Mitsubishi Electric AC Servo System

No.26-16E

Change in Appearance of Connectors of AC Servo Amplifiers

*The photo above shows MR-J5-500G-HS.

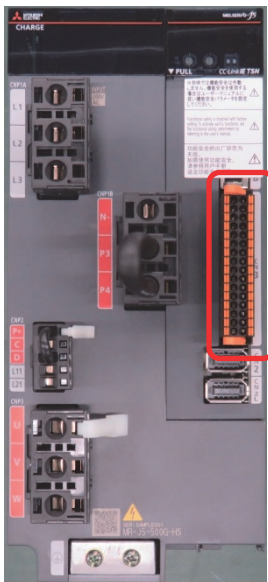
The I/O signal connector (CN3) will be changed.

Before change	After change
CN3 connector (unit side): DMC 1,5/16-G1F-3,5-LR 	CN3 connector (unit side): 1-2842540-6 
Connector set (standard accessory): DFMC 1,5/16-ST-3,5-LRBK  	Connector set (standard accessory): 1-2842539-6  
(Phoenix Contact)	(TE Connectivity)
